Ramsey Gateway Highway 10 Project

Virtual Open House Summary | May 14-31, 2021

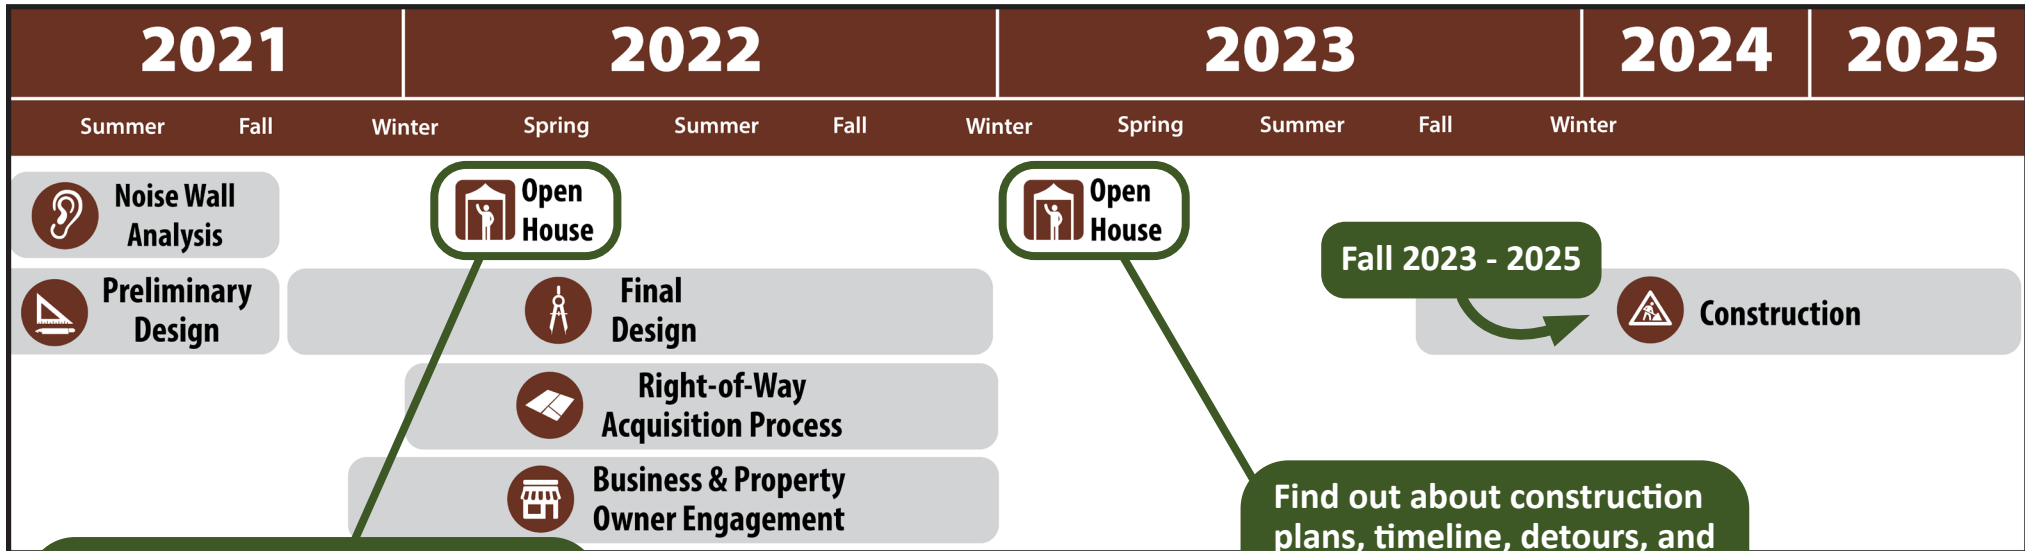
Can the north frontage road, west of Ramsey Blvd, continue to Armstrong Blvd or have direct access to Highway 10?

Will the center islands within each proposed roundabout include berms or landscape plantings? Why is this a common design element?

With the proposed improvements and per MnDOT's access spacing guidelines, an at grade access between the frontage road and Highway 10 would not be permitted. Due to the close proximity of the BNSF Railway and Highway 10 near Armstrong Blvd, extending the north frontage road to that location is not feasible as it would require very costly and impactful reconstruction of the highway and the interchange ramps.

The project team has yet to determine recommendations for the roundabout center island treatments. The reasons that berms or plantings are intentional design elements is to increase visibility of the intersection for approaching drivers, to promote lower speeds by decreasing excessive sight distance, and to focus the driver's sight lines on pedestrians near the crosswalk and vehicles approaching from the left.
